Sunnica Energy Farm

Written representation relating to LGC Campus on behalf of HPUT A Limited and HPUT B Limited

PINS Reference: 20031202

Figure 15

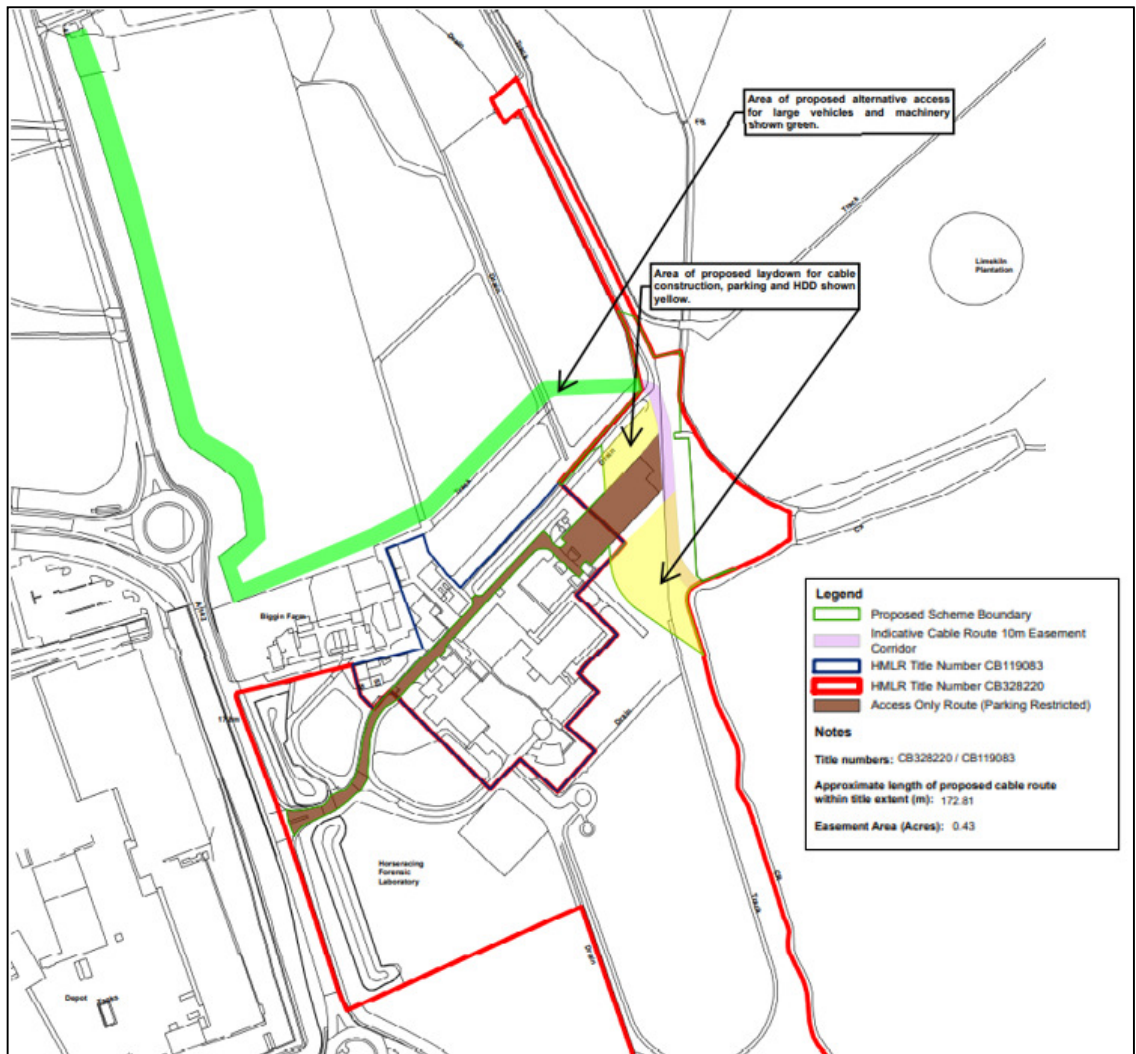
- 12.4 Fundamentally, the Campus is not suited to conveying third party construction traffic of any scale and it is not clear why all such traffic cannot be routed via alternative access arrangements. Nor is it yet clear that the vibration impacts from construction within the land coloured yellow are acceptable given the catastrophic implications for the scientific activities described above. Even so, FHPUT's consultants will continue to engage with Sunnica in an attempt to explore whether these recent proposals are sufficient to overcome its objection.

12.2.1 Areas for construction laydown and parking for Sunnica vehicles are coloured yellow (within an area currently the subject of proposed Access Rights) to the north and south of the Campus car park coloured brown (an area currently the subject of proposed Access Rights).

- 12.2.2 All HGVs are now to be routed via the route coloured green/blue/mauve in Figure 15 above, within the area of land located to the north of the Campus, instead of routing HGVs through the Campus access road.

- 12.2.3 Only cars / light vans would route through the Campus's access road to access the laydown and parking areas coloured yellow with a maximum of 15 cars / light vans per day.

- 12.2.5 HGVs would access the proposed laydown and parking areas via the cable route corridor coloured purple, avoiding the need for them to access the Campus car park within the area coloured brown.

- 12.2.6 There would be no parking permitted by vehicles associated with the Scheme on the area coloured brown.
- 12.3 FHPUT welcomes the direction of travel demonstrated in these revised proposals, albeit in the frontloaded DCO regime it is disappointing that it should have taken so much effort on the part of a landowner to have reached this a position at such a late stage. Furthermore, given that these assurances have only recently been offered by Sunnica and are yet to be properly assessed by FHPUT or secured, they do not overcome the objection to the DCO Scheme.
